**Re-evaluation
of the
Final Environmental Impact Statement**

**US 93
Evaro to Polson**

October 22, 2001

F 5-1(9)6 U.S. Highway 93, Evaro – Polson
Missoula and Lake Counties, Montana

Figure 2 Evaro

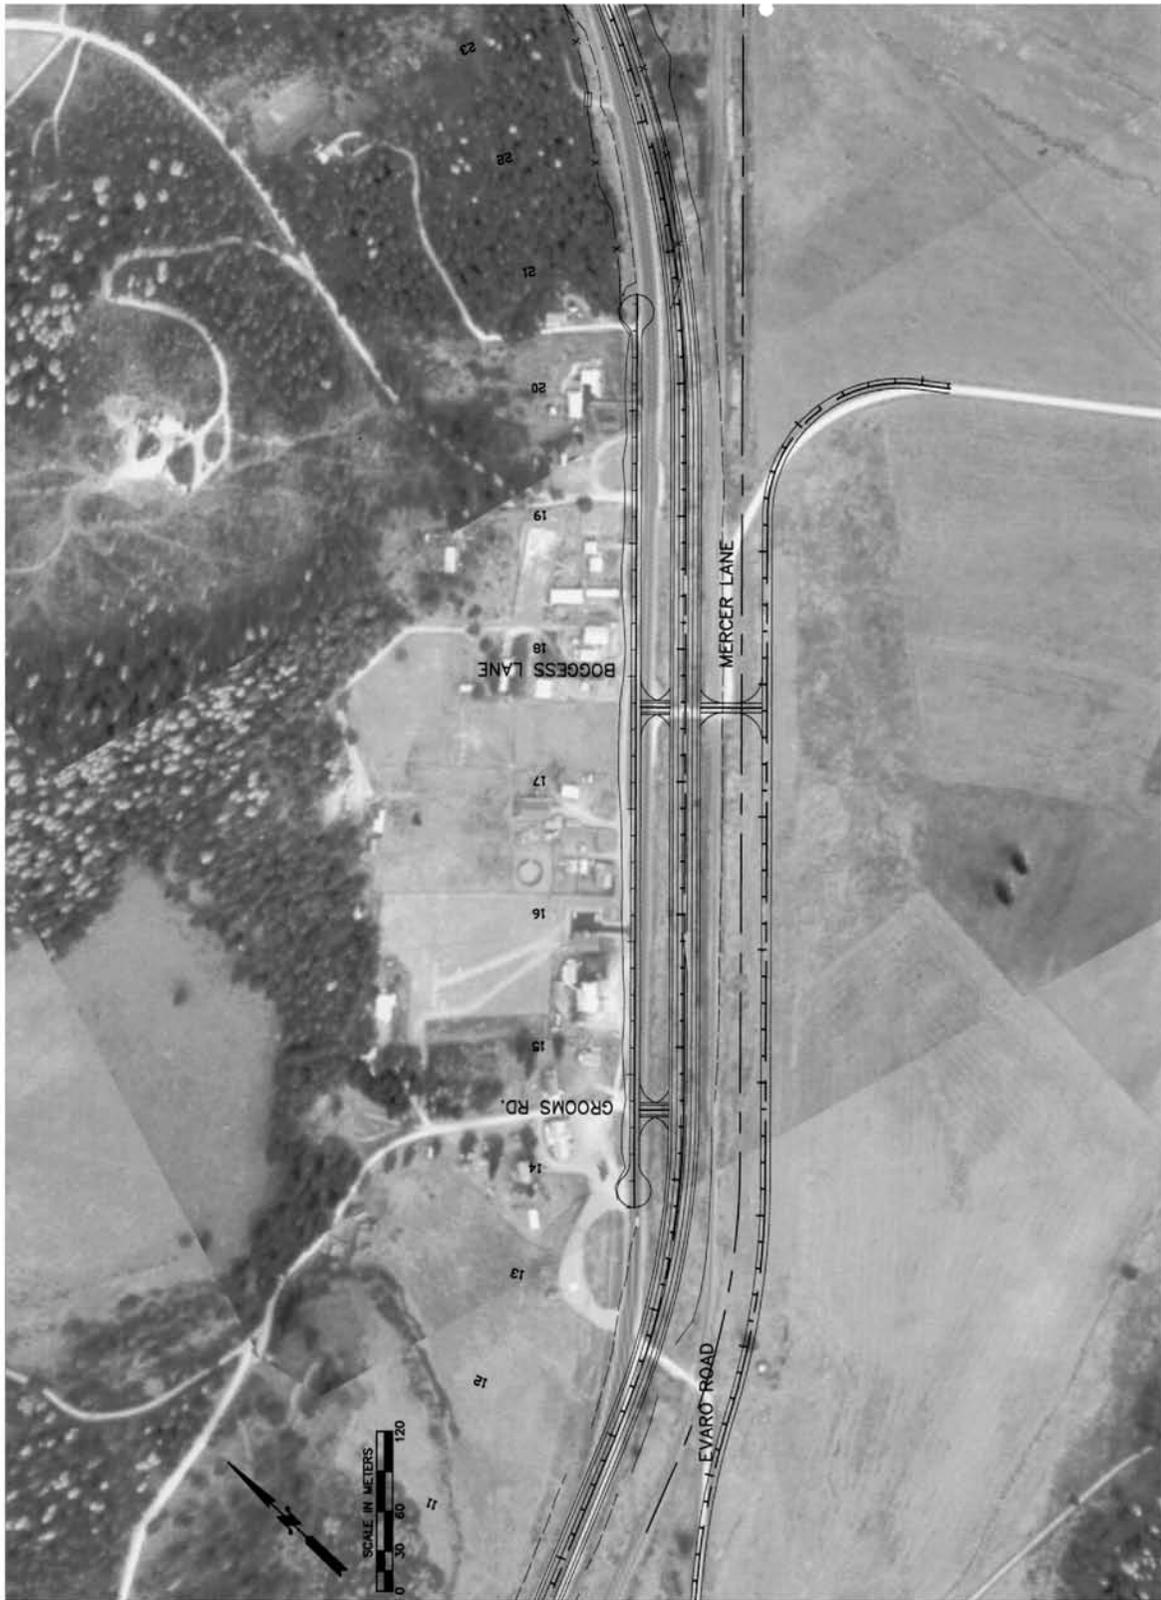
The MOA proposed a 4-lane roadway with a frontage road for this area.

Following input from the citizens of Evato, the design for that area was changed to lessen impacts on their community while still providing a safe highway. Those changes are as follows:

- The highway alignment, frontage road, and the railroad will be shifted to the east to minimize right-of-way impacts to the Evaro community.
- The north access will be shifted south away from the north curve to approximately intersect with Mercer Lane. The south access will be located a little farther north of the south curve at Grooms Road.

- The two railroad crossings to the east will be combined and located at Mercer Lane.
- Several citizens asked for multiple accesses and a two-way left turn lane instead of a frontage road. This option was studied for traffic and safety, and it was confirmed that a frontage road is the safest option for this location. A frontage road will provide safe local circulation and a safe place for school buses to load and unload. Evaro's location between the crest of a hill and a curve limits the number of safe options available. It should be noted that residents have created and use an unofficial frontage road in the highway ditch for local access.

Figure 5 Jocko River

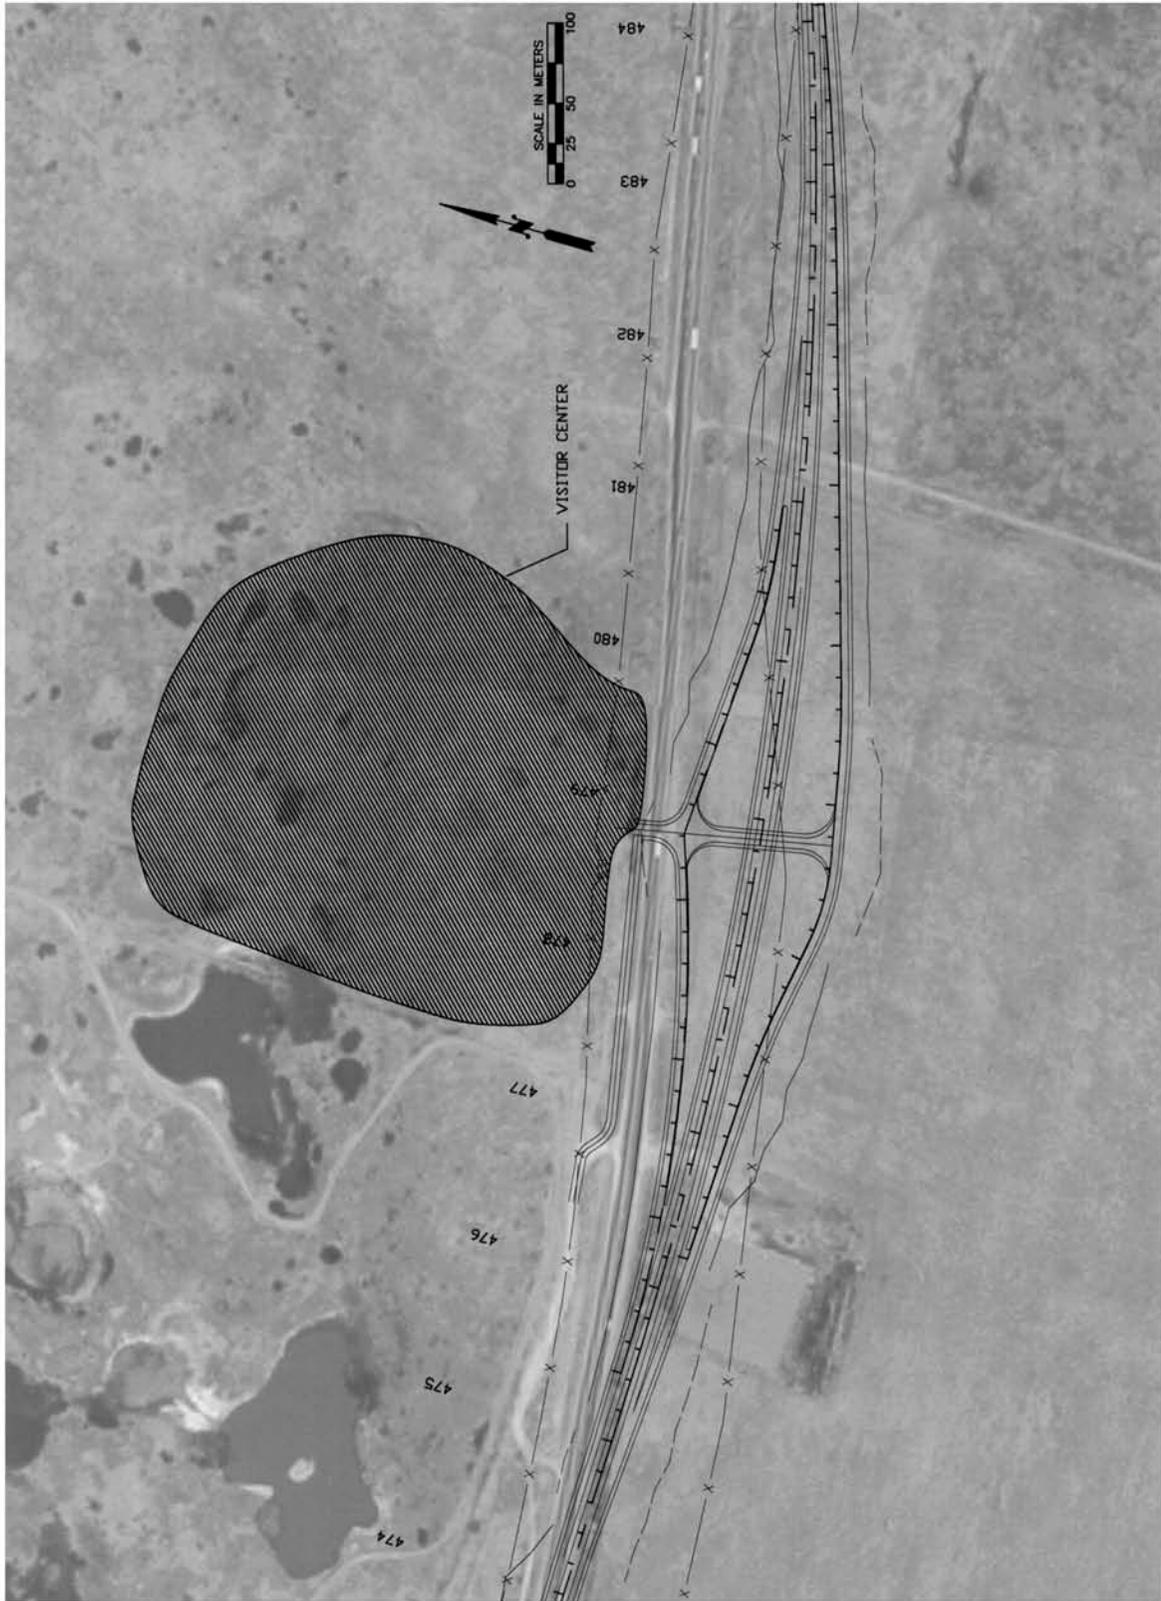
Jocko River and Dumontier Road (See Figure 5)

The three governments now have selected a 3-lane roadway with a southbound passing lane in this area. They also will provide a 2-lane access road from Dumontier Road following the Old 93 route northward until it ties into US 93 approximately 950-1000 meters north of the existing access.

Figure 9 Glory Road

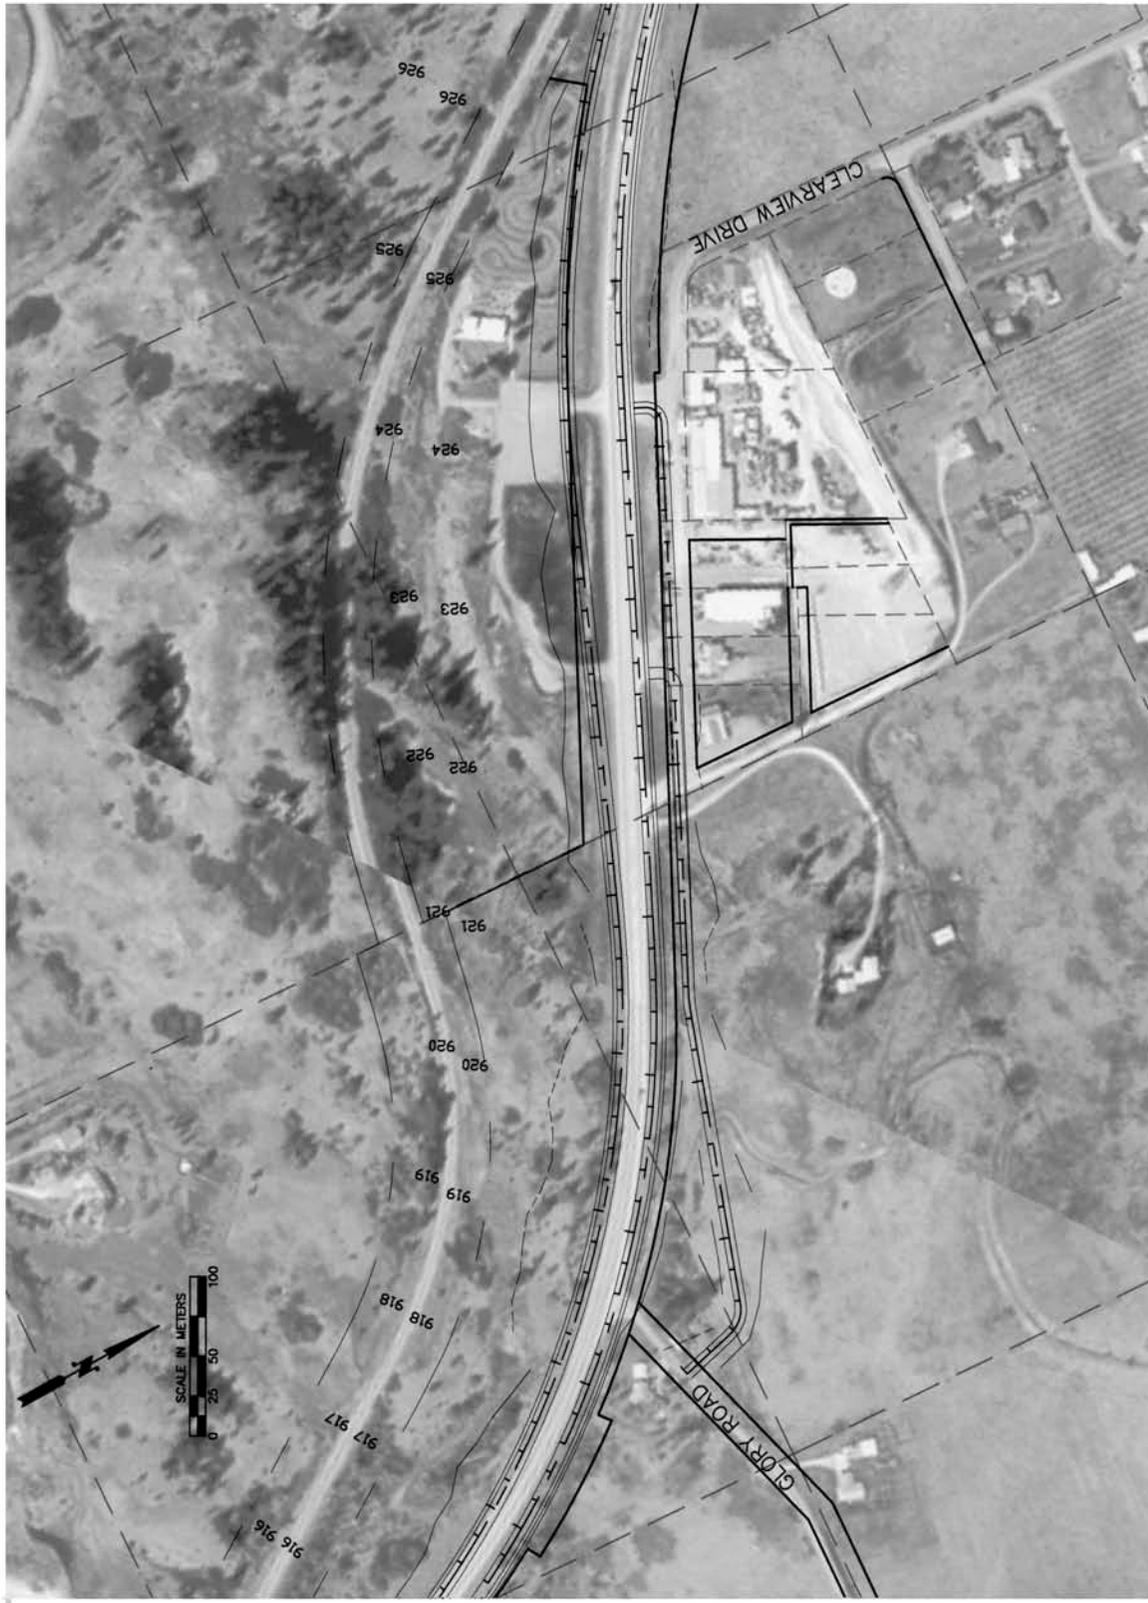
The MOA proposed a divided 4-lane roadway in this area. Rather than follow the existing alignment, it was more curvilinear with varying median widths and vertical alignments to better fit the land and enhance views of Flathead Lake and the other surrounding landscape. It included closing the Glory Road access and the use of a frontage road from Glory Road to a new access 400 meters to the north.

The three governments have now selected a divided 4-lane roadway in this area with a more curvilinear alignment with varying median widths and vertical alignments to better fit the land and enhance views of Flathead Lake and the other surrounding landscape. This selection will include closing the Glory Road access and the use of a frontage road from Glory Road to a new access 600 meters to the north. This frontage road was moved from within the existing right-of-way to the east to reduce the impact on the vegetated hillside to the west. The access point to US 93 was moved another 200 meters north and has impacts to parking for the businesses on the east. Further efforts will be made to minimize these impacts during project design.
